AGENDA

La Vergne Planning Commission
July 29, 2025 at 6:00 PM

Item #: 3. Site Plan – Smoke Club 13 – New Building of 2,759 Square Feet on 0.42 Acres. Requested by Dean Design Group. Property located at 5234 Murfreesboro Road (Tax Map 15M, Group C, Parcel 6). C-2 (Highway Service) Zoning District. Property owned by Smoke Club 13, LLC. (DEFERRED)

Initial Sediment Control Plan
Demo & Erosion Control Plan

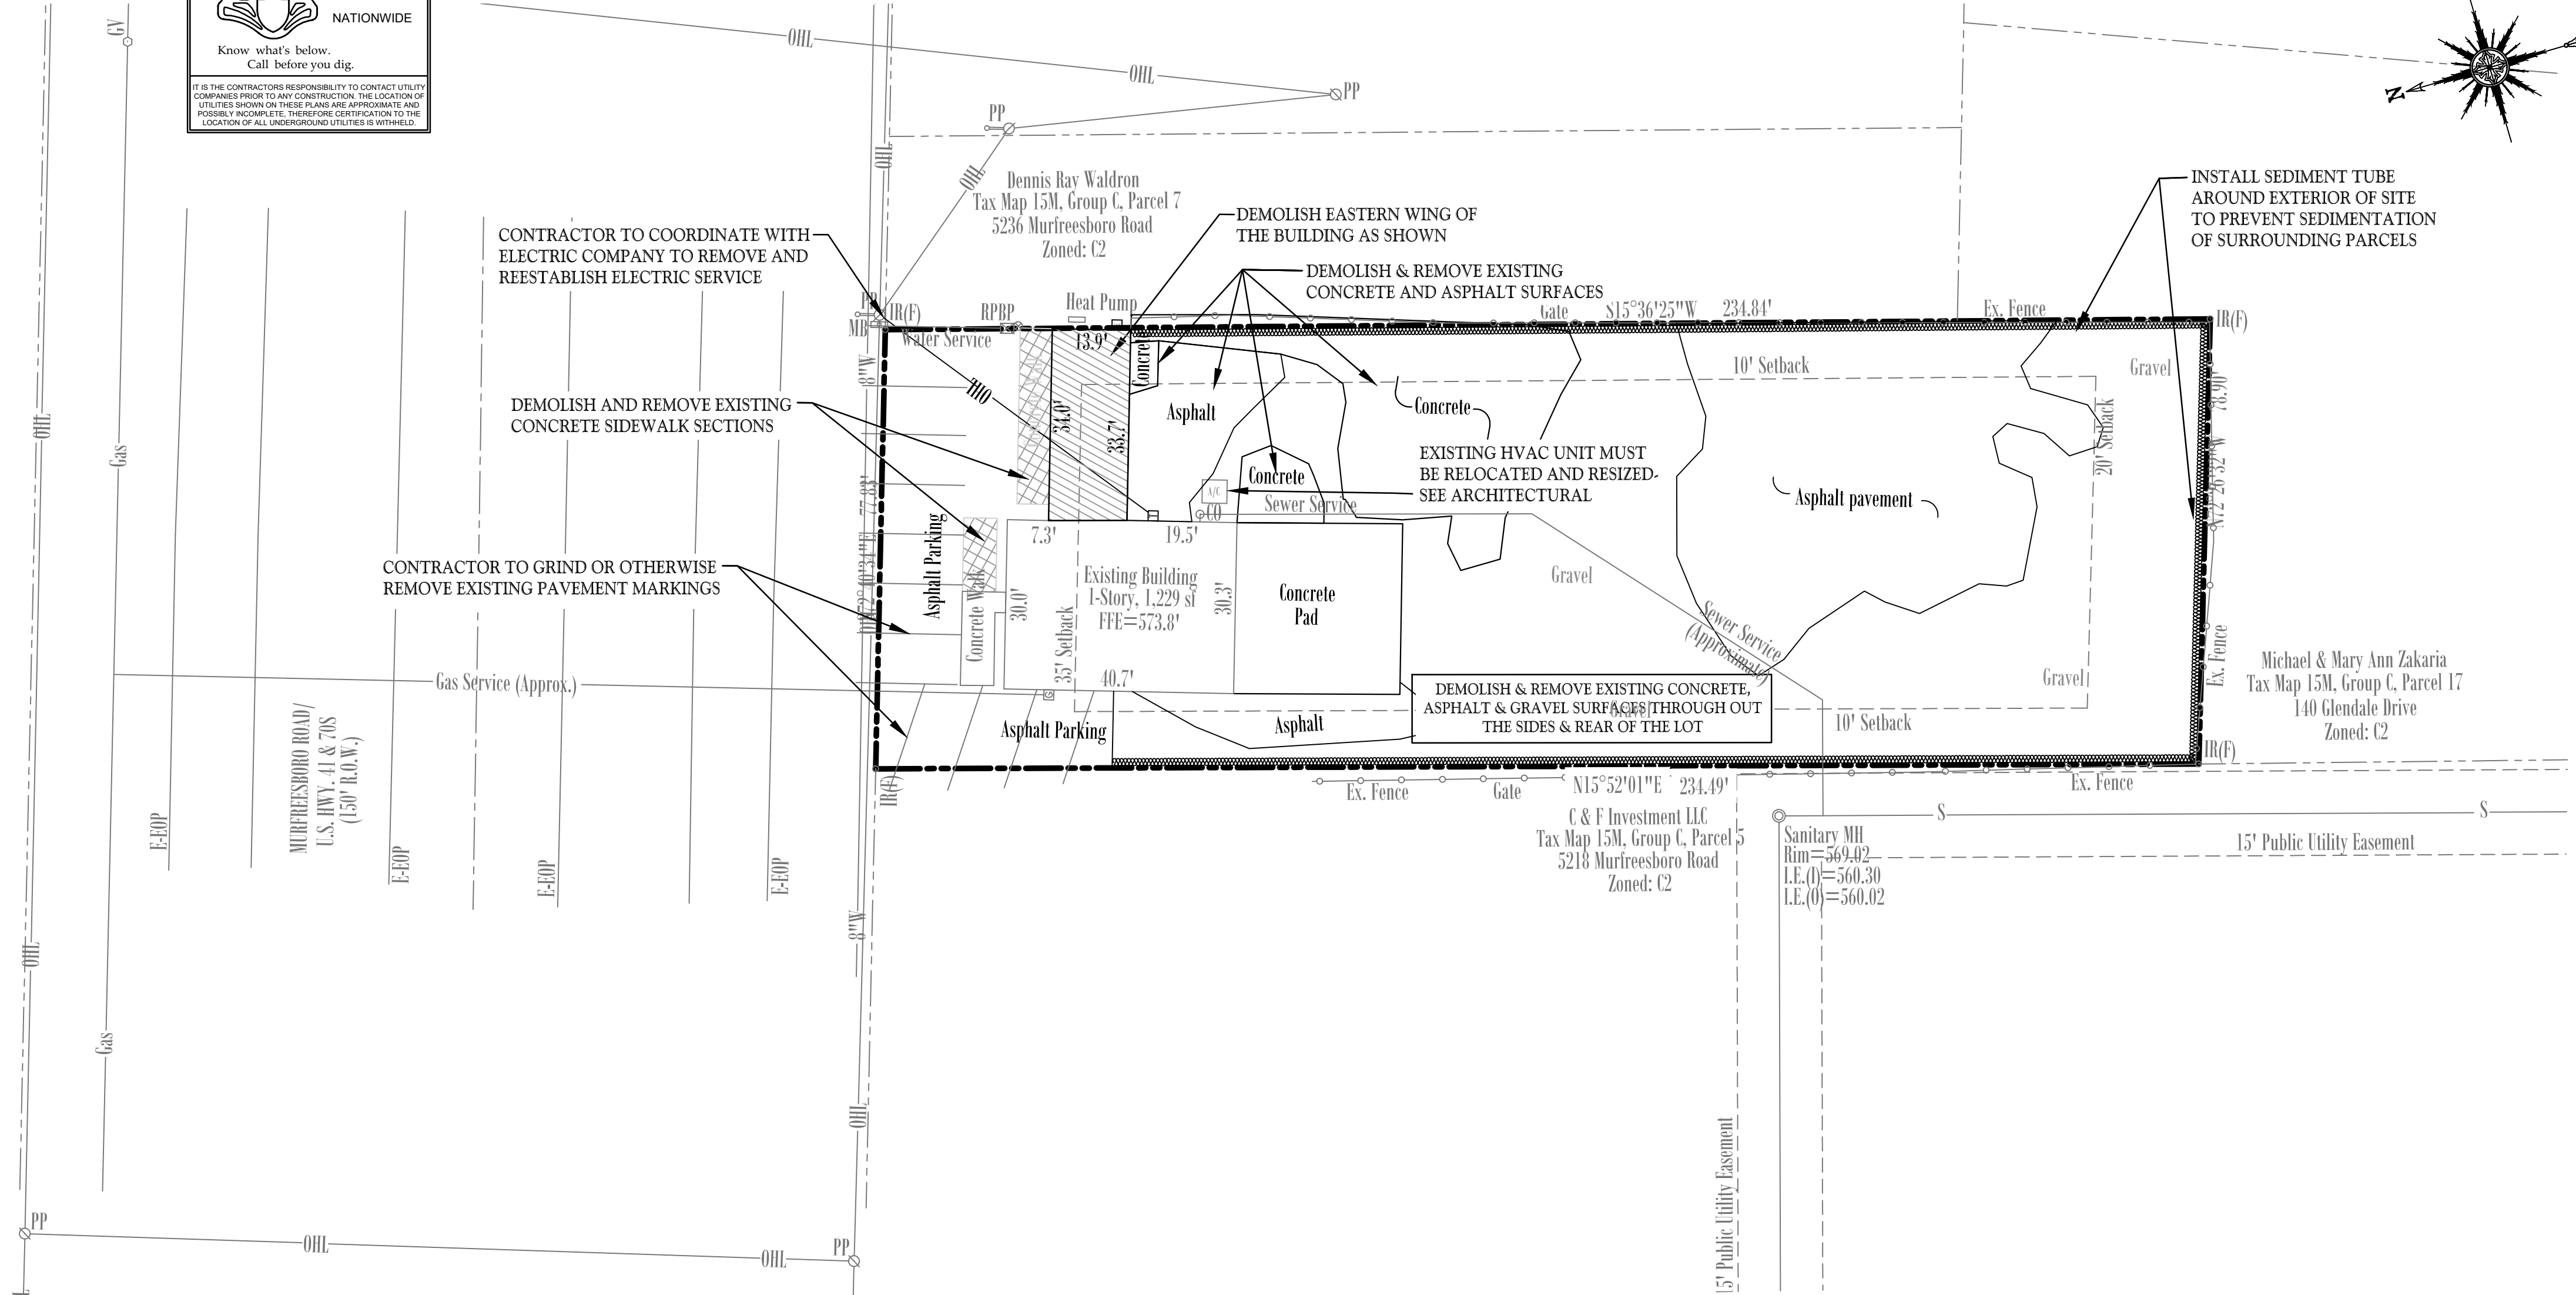
1. Show stakes on both sides of wattle tubes (eels) on the detail.
2. Submit a filled-out Longterm Maintenance Agreement (LTMA) which includes a Longterm Maintenance Plan (LTMP). Get with Alexandra Thompson (615-287-8658) for assistance.
(<https://www.laveragnetn.gov/DocumentCenter/View/3971/Long-Term-Maintenance-Agreements---La-Vergne>)
3. Show the building footprint on the Dennis Ray Waldron property to the north as previously requested by the Planning Commission

C1.2
EROSION
CONTROL PLAN

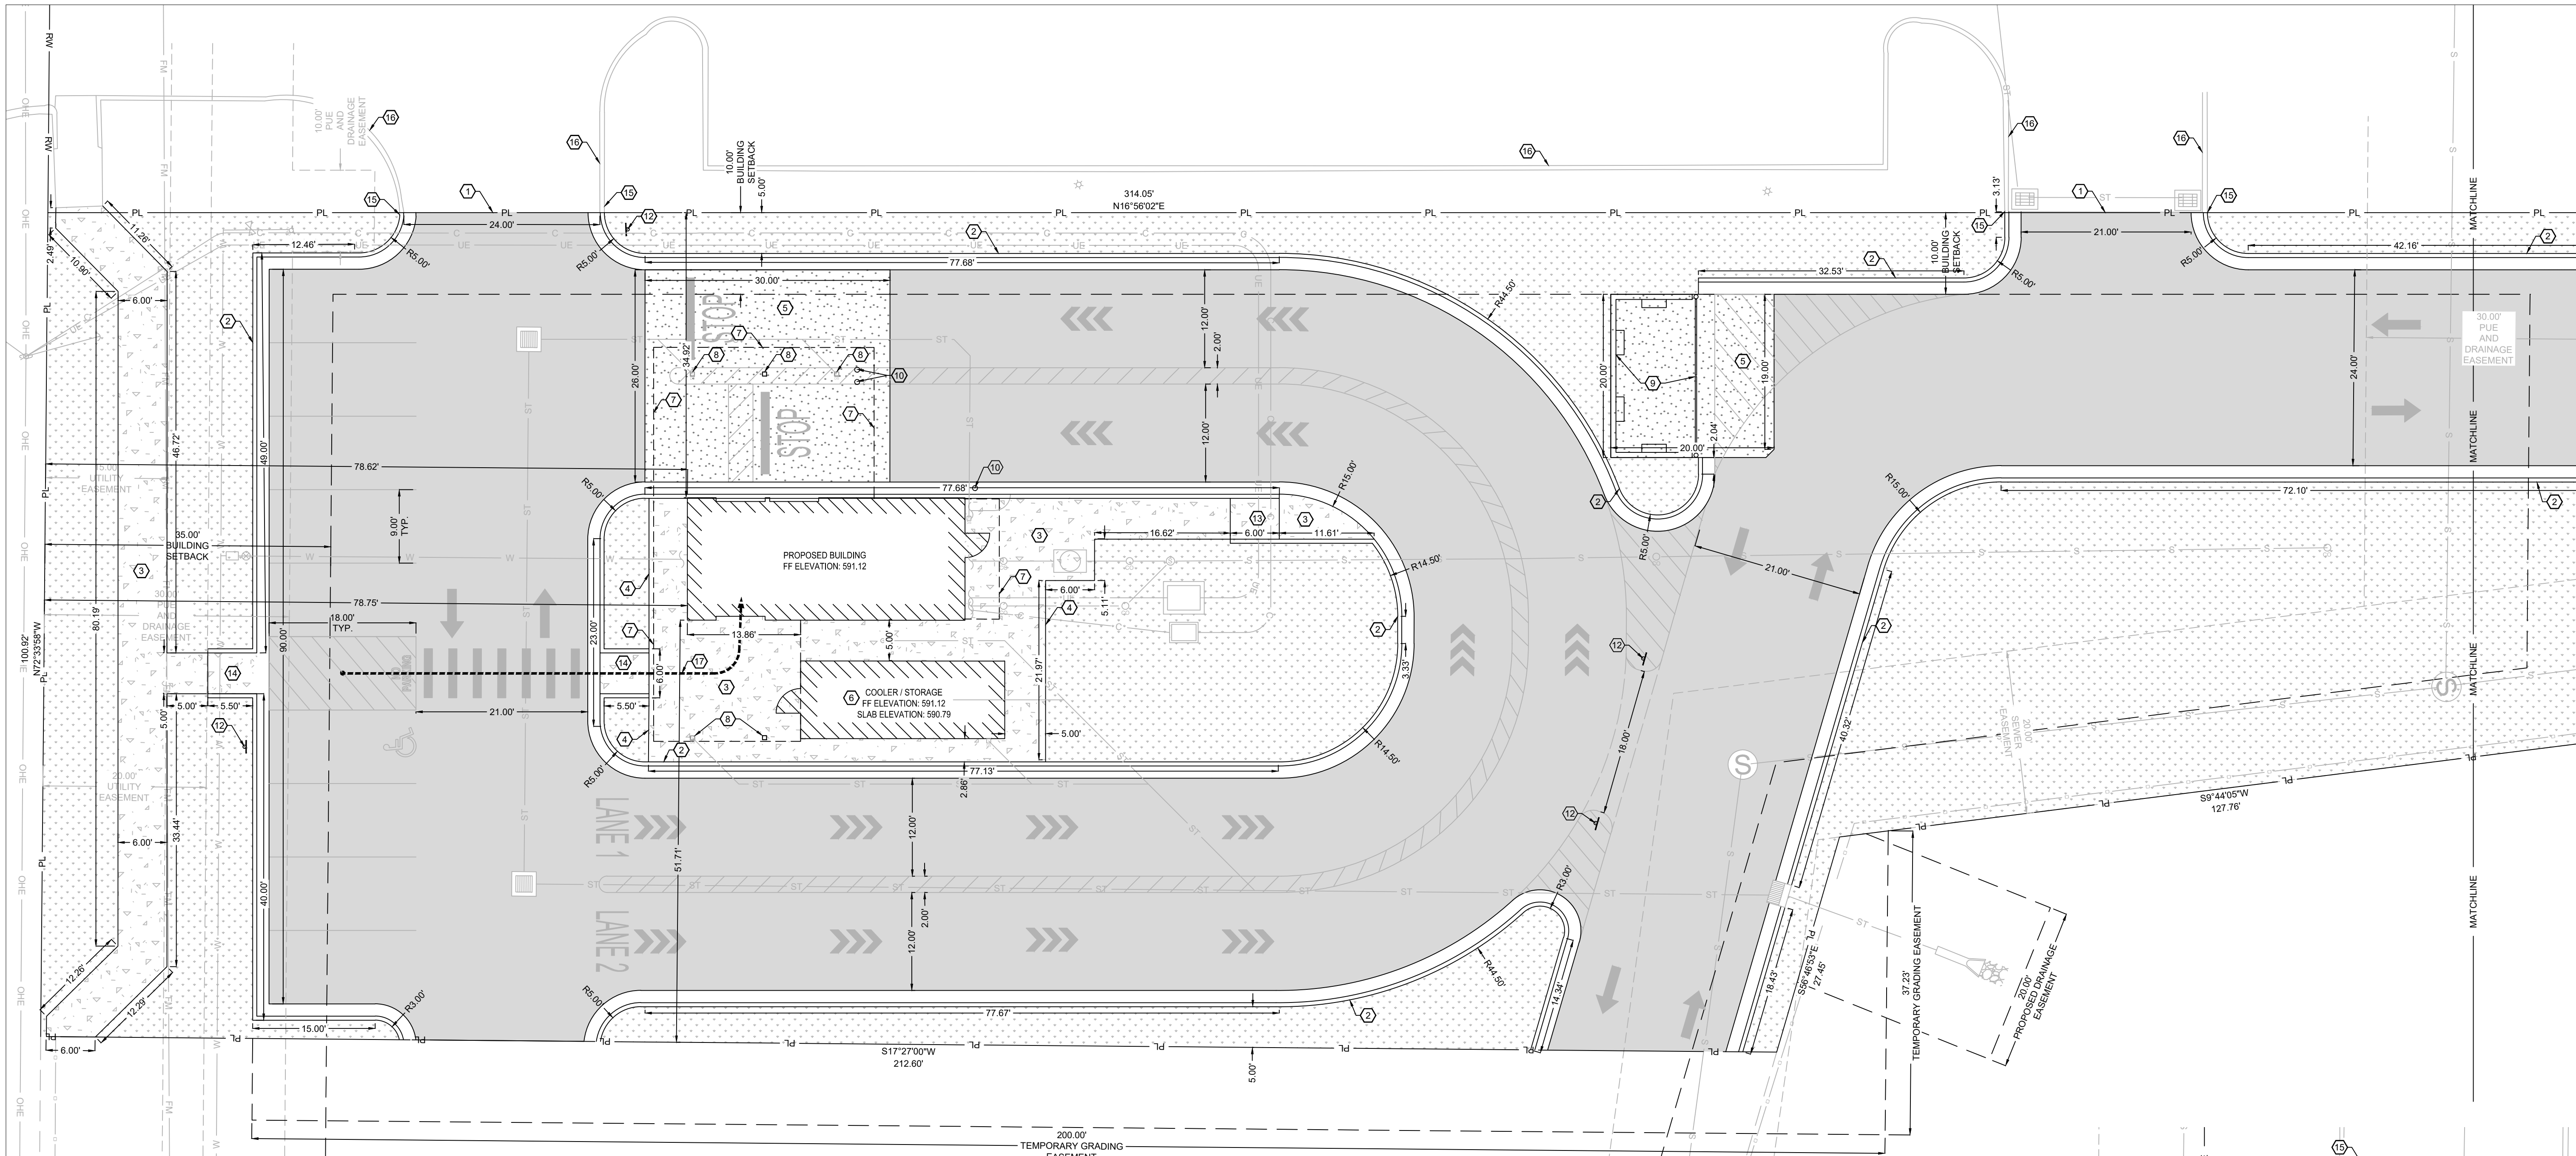
6. (Sheet C1.2) Silt fence and limits of disturbance are shown outside of proposed drainage easement.

C2.1
SITE PLAN

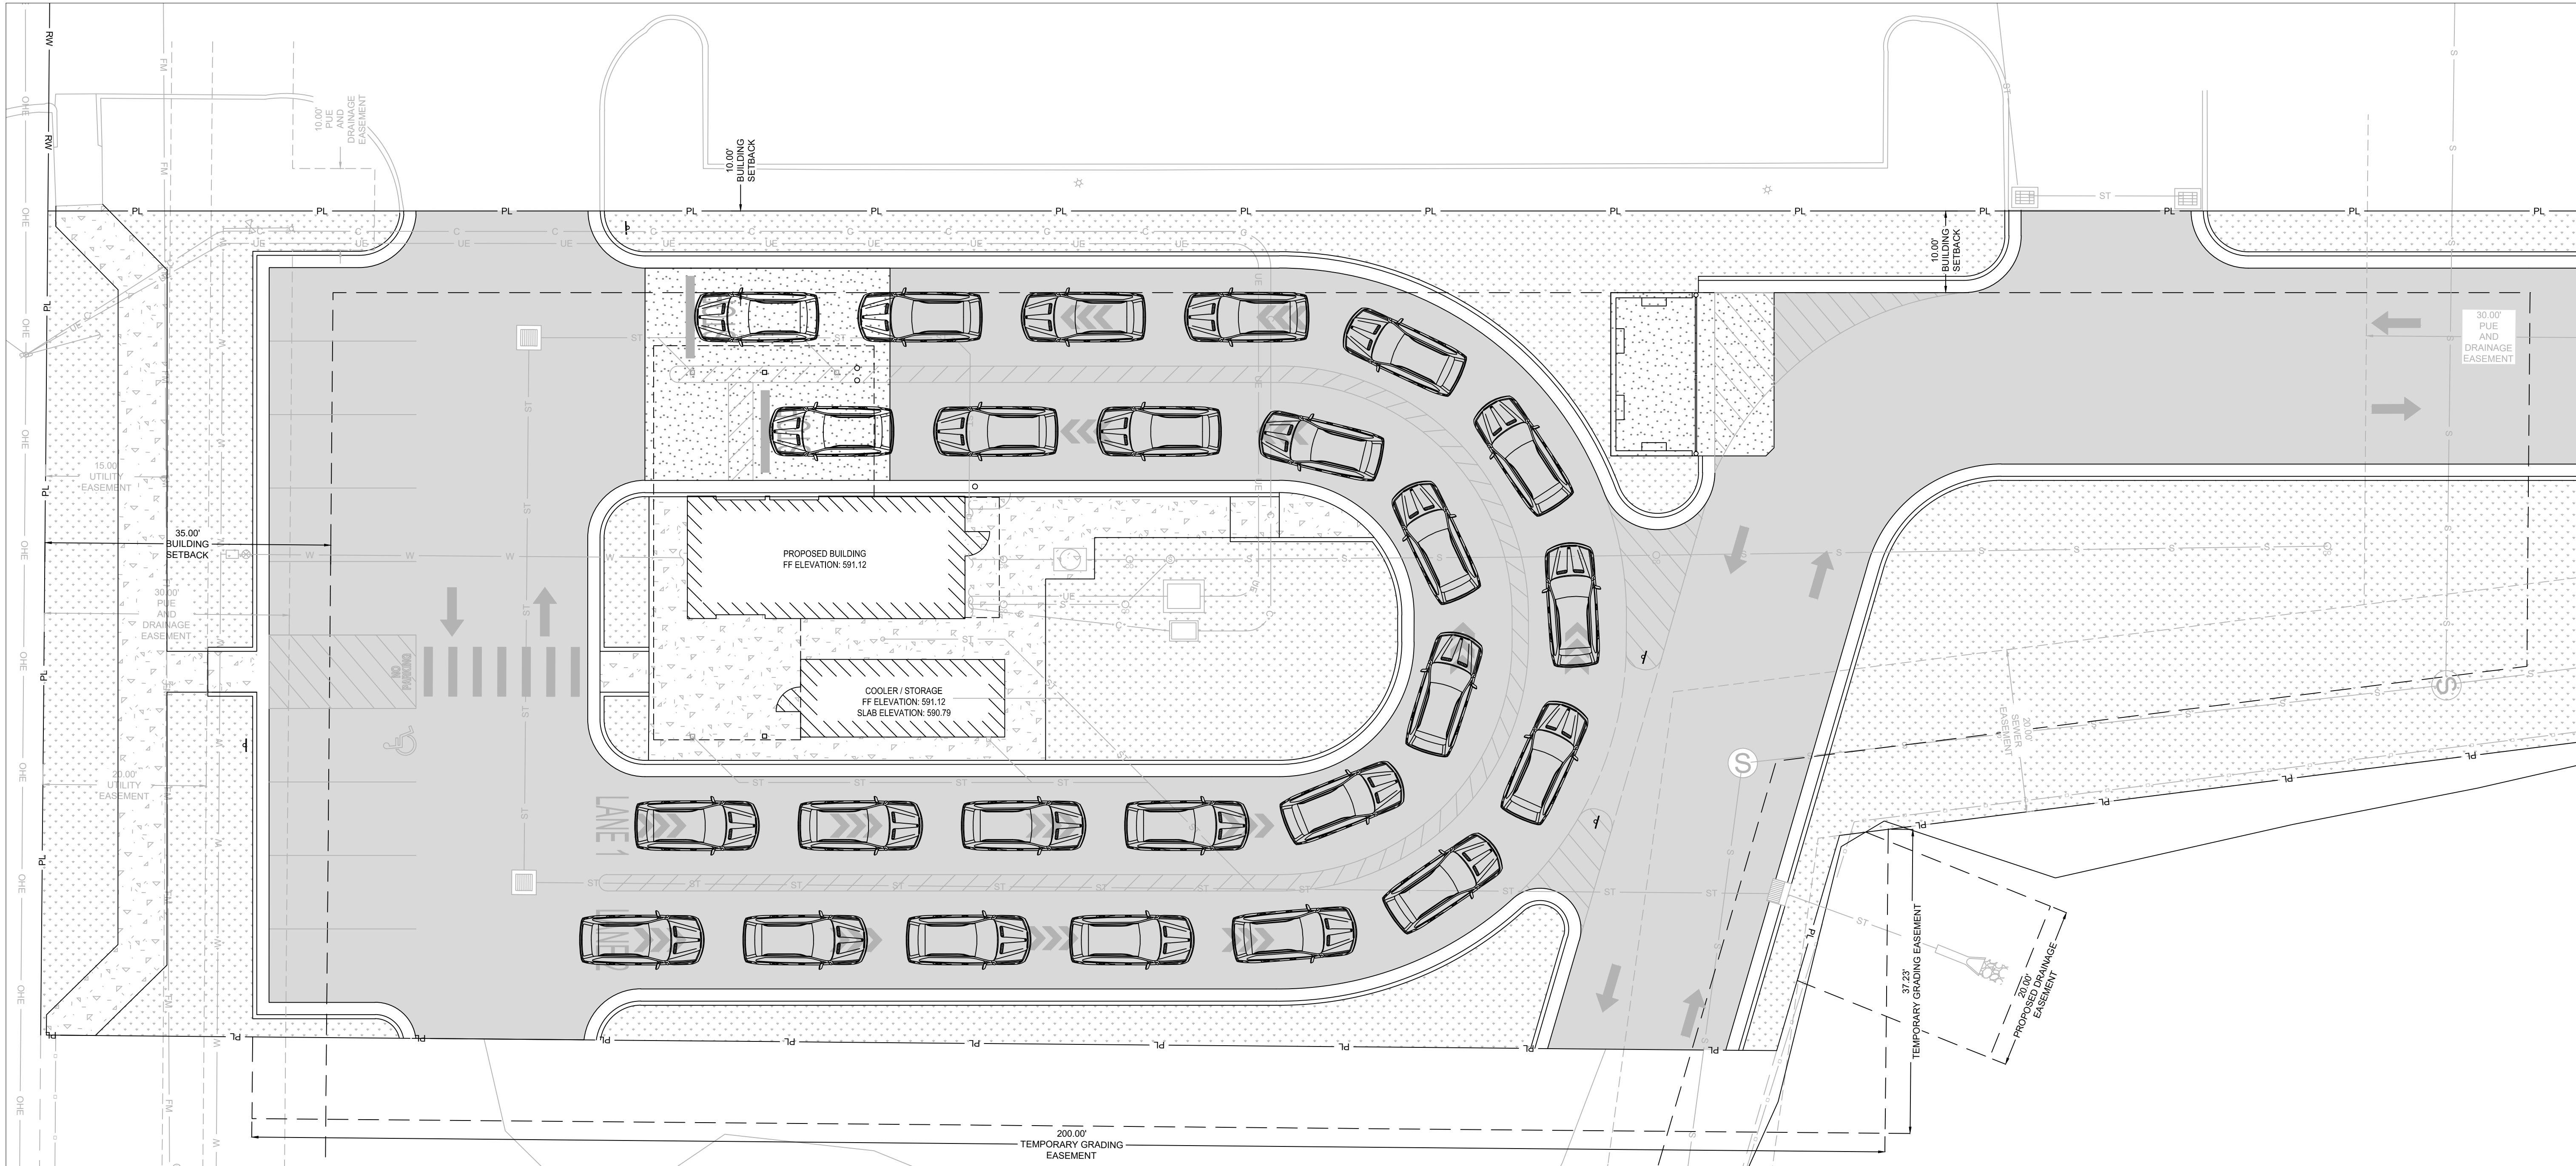
5. (Sheet C2.1) Dumpster enclosure wall and gate elevations and details were not found in the architectural plans.
